Attorney Docket No.: 46440-0009017

Presented for filing is a new continuation patent application for prioritized examination of:

Title: BI-DIRECTIONAL FIXATING TRANSVERTEBRAL BODY SCREWS AND POSTERIOR CERVICAL AND LUMBAR INTERARTICULATING JOINT CALIBRATED STAPLING DEVICES FOR SPINAL FUSION

Fig. 2C

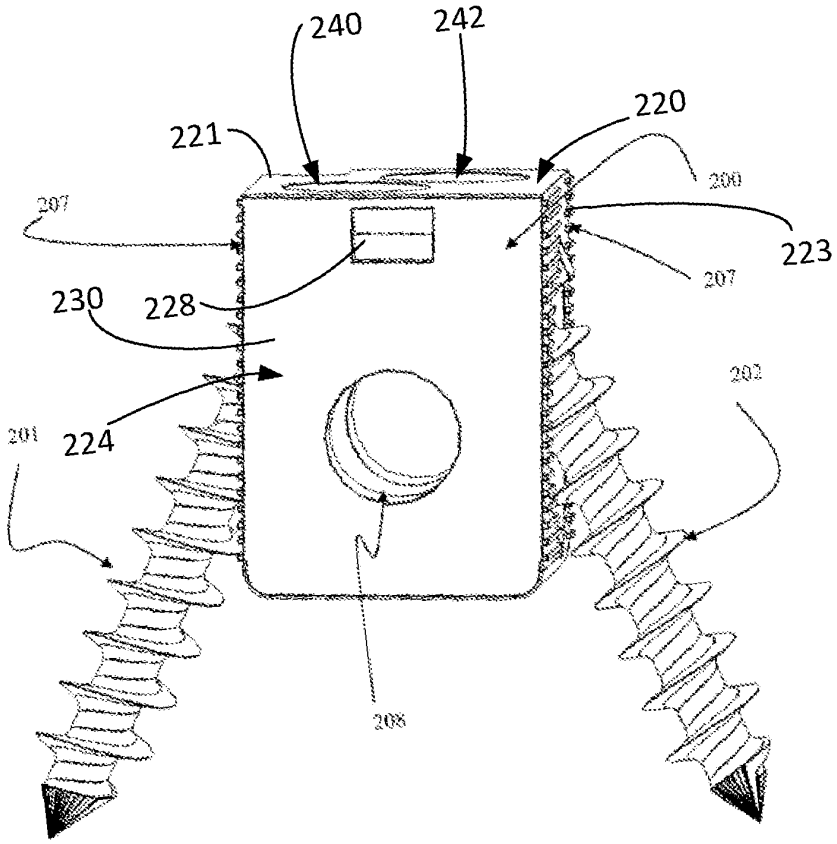
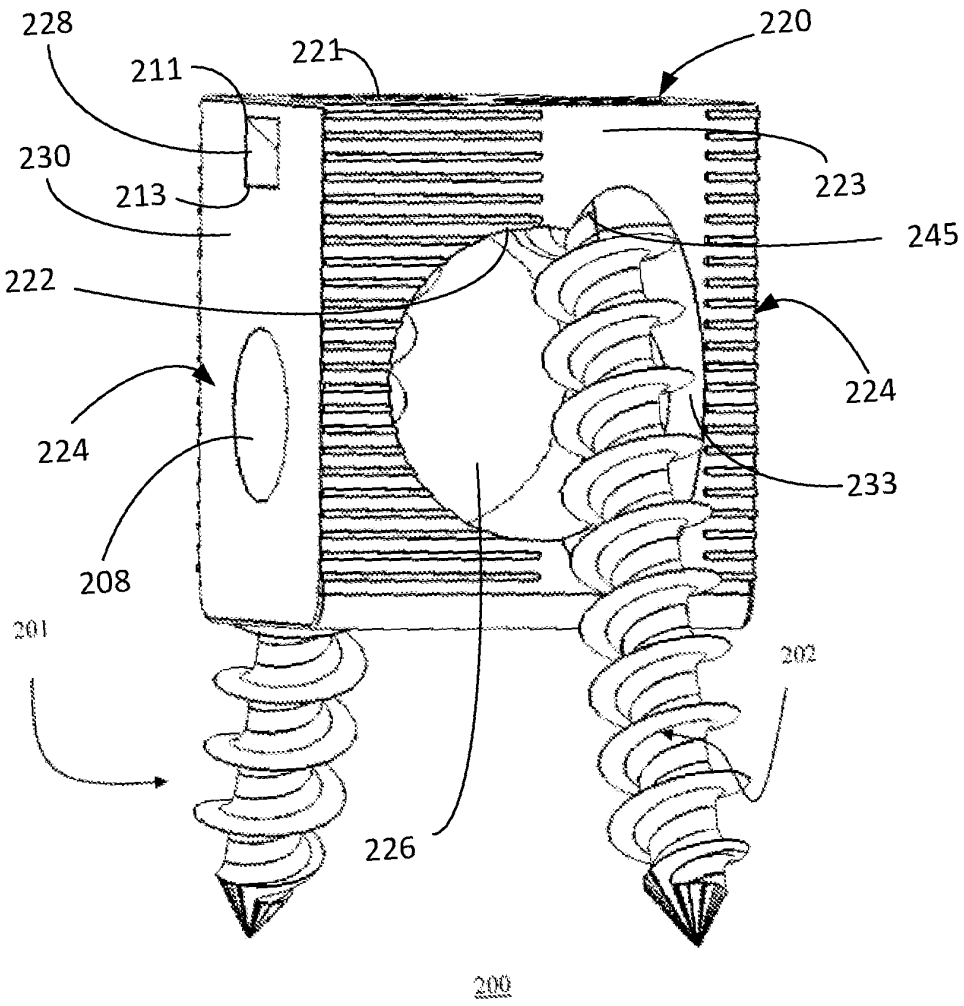
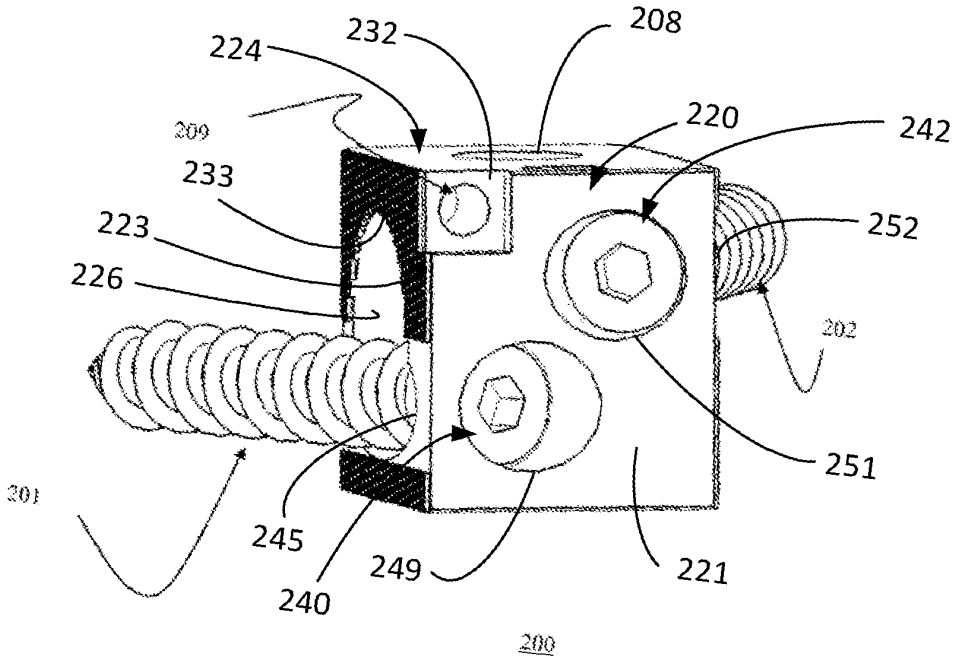
Additionally, Figs. 2A and 2B both illustrate the same side of the implant and therefore should both be given the same name, i.e., the first sidewall (element 224). The examiner understands that the implant has two separate sidewalls but it is noted that only a single sidewall is visible from the Drawings.

The attached replacement sheets of drawings (3) includes changes to Figs. 2A-2C and replace the original sheets including Figs. 2A-2C.

In Figures 2A-2C, reference numerals and lead lines are revised to correspond to the reference numerals associated with the structures recited in the claims in newly amended paragraph [0064.1].

Regarding the sidewall (element 224) in Figures 2A and 2B, a Replacement Sheet has been included herewith to amend Figures 2B and 2C to use reference number 224 instead of reference number 225. Additionally, paragraph [0064.1] has been amended. Applicant believes that these amendments render this objection moot.
